## INTRODUCTION

Since the introduction of the THM 440-T4 Transaxle in April, 1984, there have been many major engineering design changes. These changes have affected nearly every part used in the THM 440-T4. This Update Handbook will explain each change, the parts affected by the change, and any parts interchangeability problems created by the change.

### THM 440-T4 PUMP INFORMATION

Figure 94

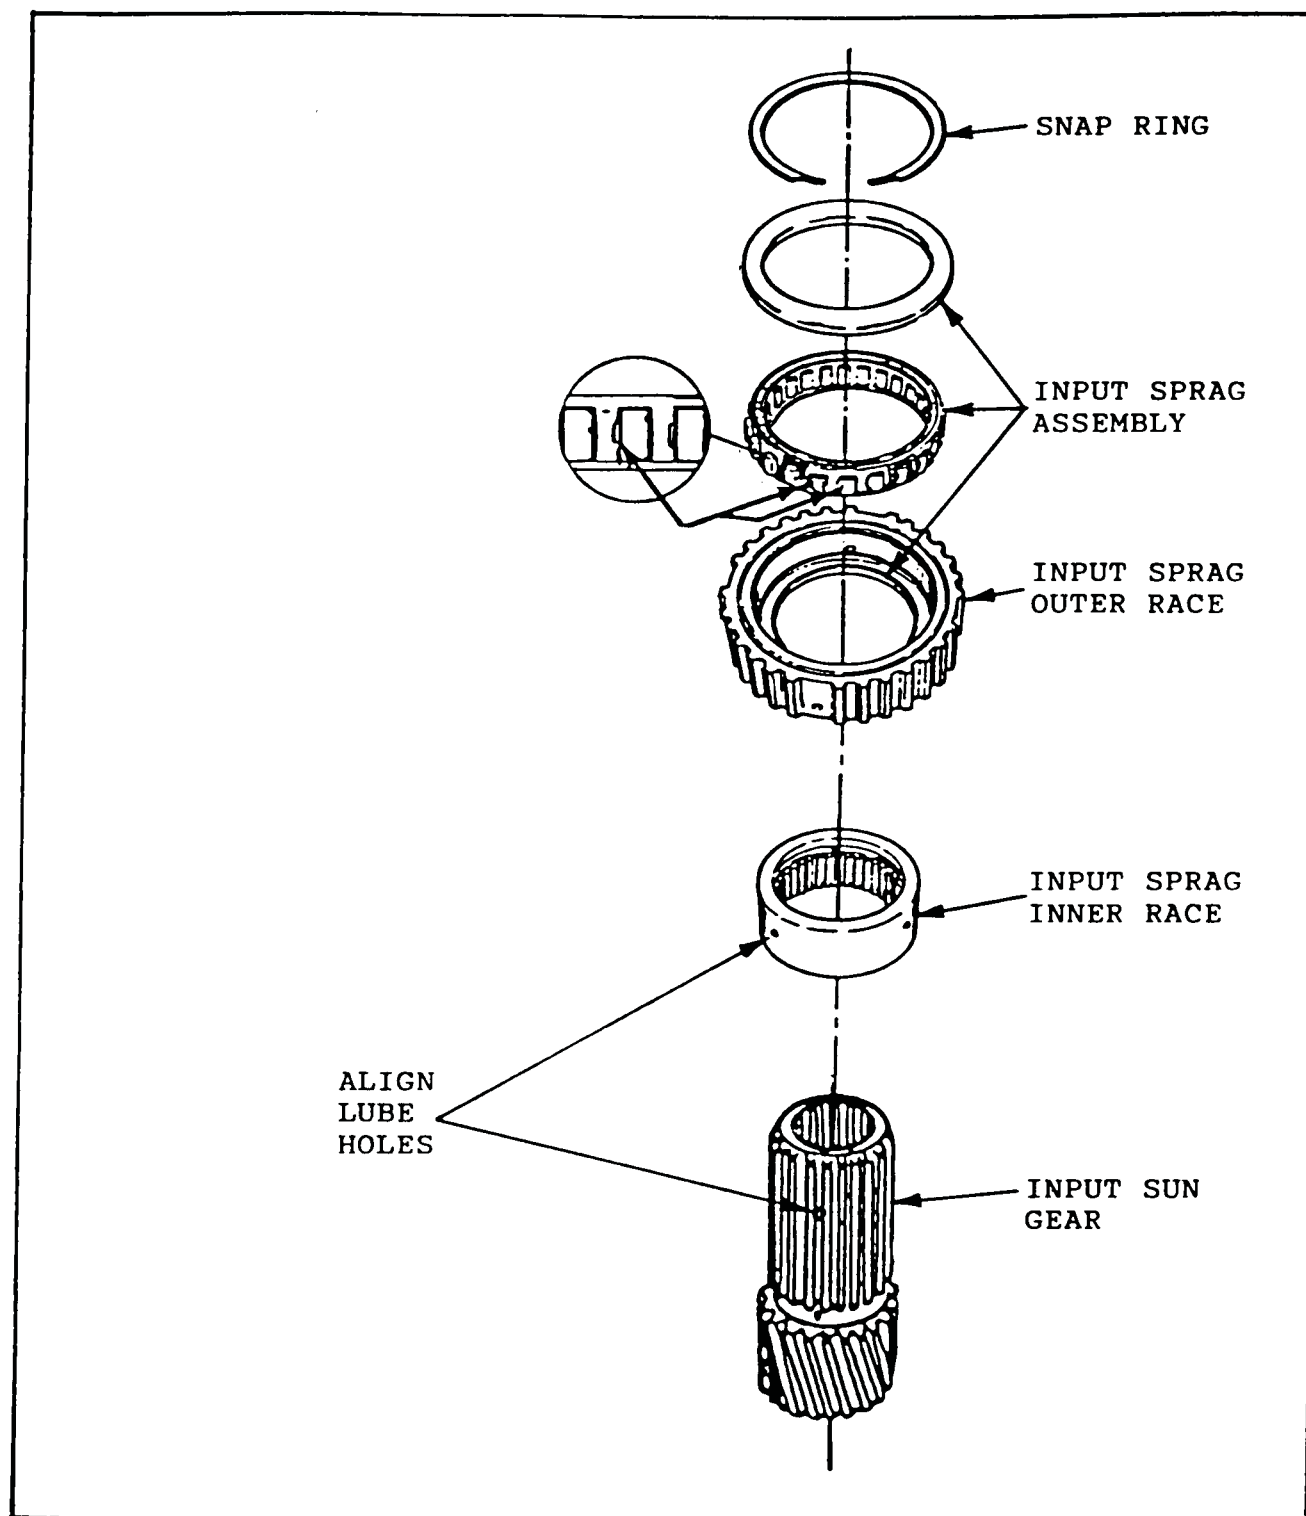
3. MODIFY ASSEMBLY PROCEDURE:  
When installing the Sprag Assembly onto the Input Sun Gear, align one of the three lube oil holes in the inner race, with one of the two lube oil holes in the Input Sun Gear, as shown in Figure 94.

Figure 95

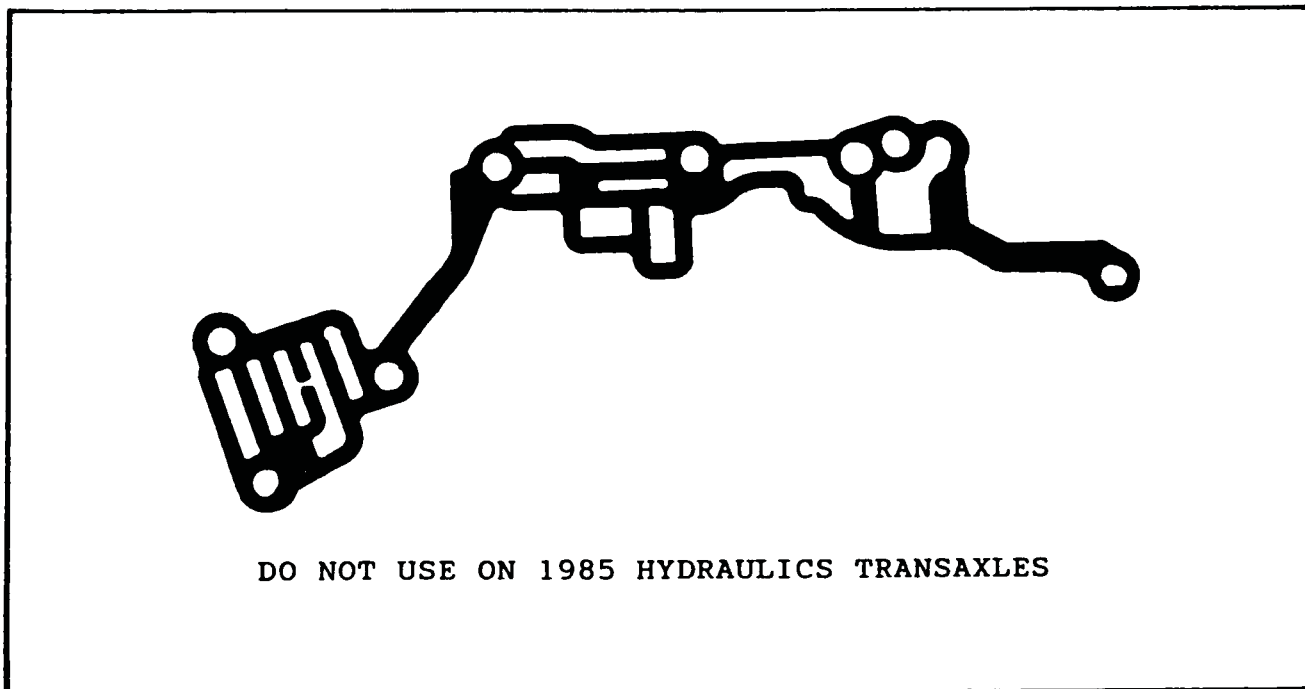
**CHANGE:** Upper Channel Plate Gasket (See Figure 95).

- (1) Upper Channel Plate Gasket - The Upper Channel Plate Gasket and Modulator Port Gasket are now connected together as one gasket (See Figure 95).

Figure 96

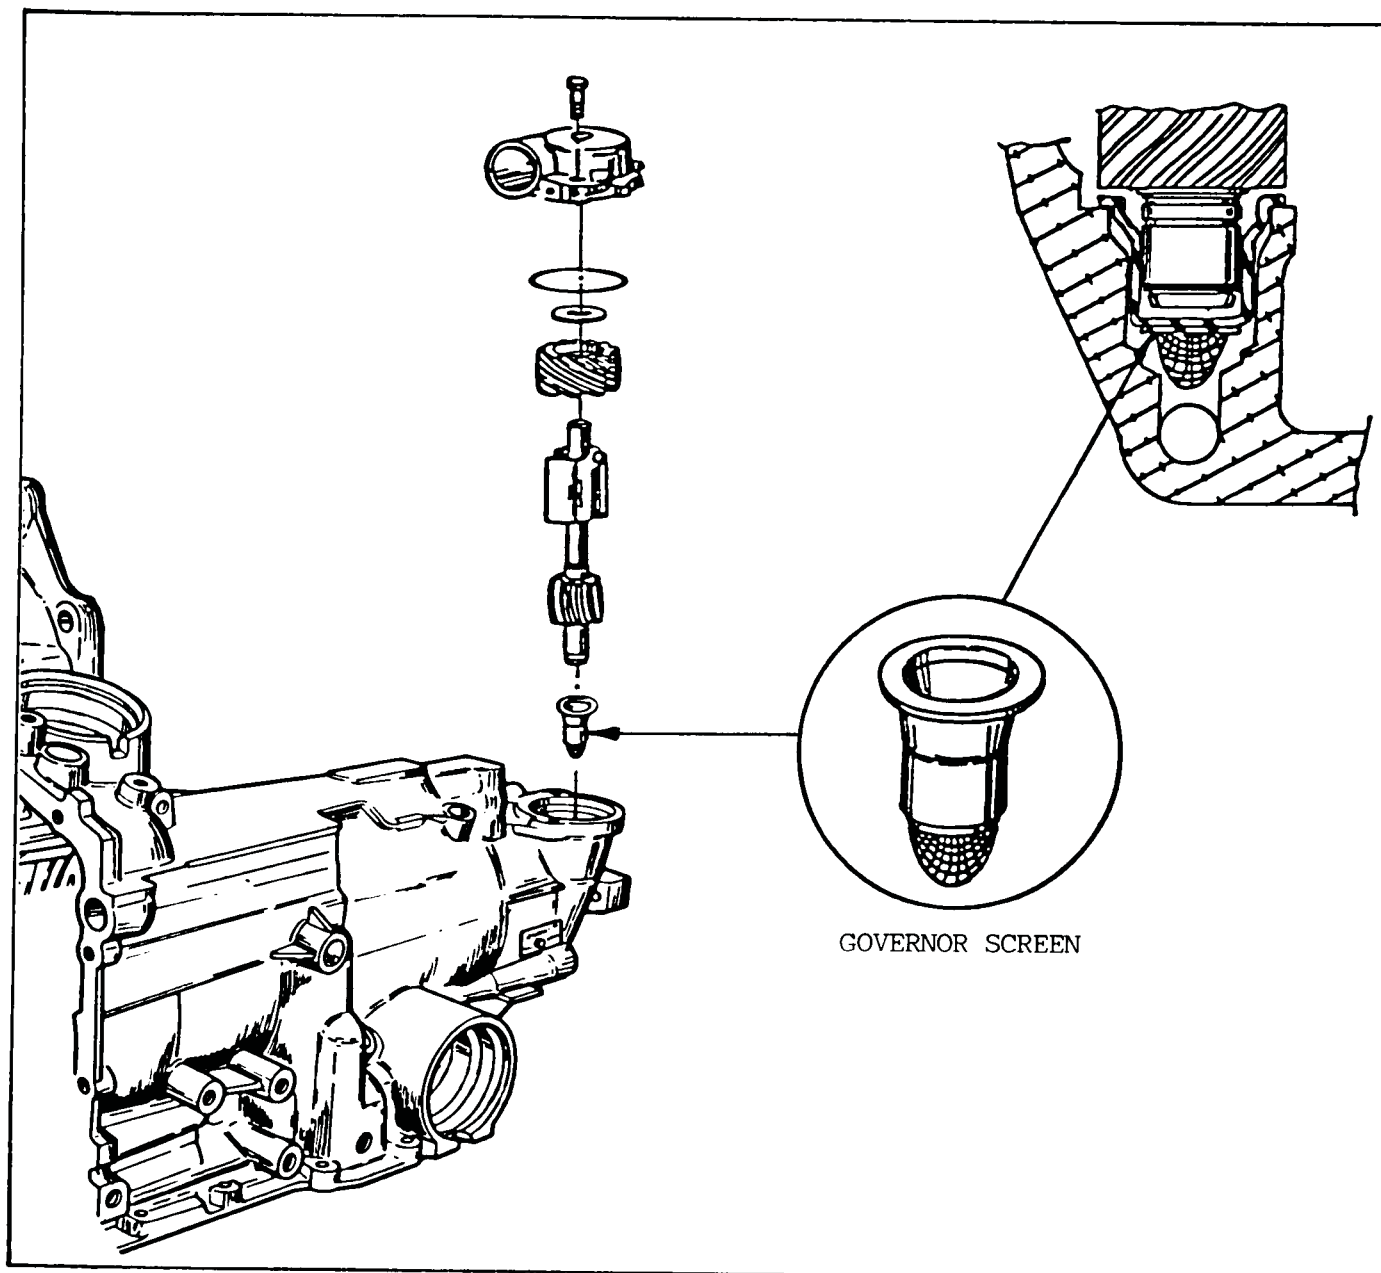
The governor screen was added in 1989 to the governor sleeve in the case, to minimize the possibility of sediment entering the governor assembly and preventing the governor balls from seating properly. (See Figure 96).

A machining change was necessary in the case to make room for the new governor screen, thus it will not retro fit to previous models.
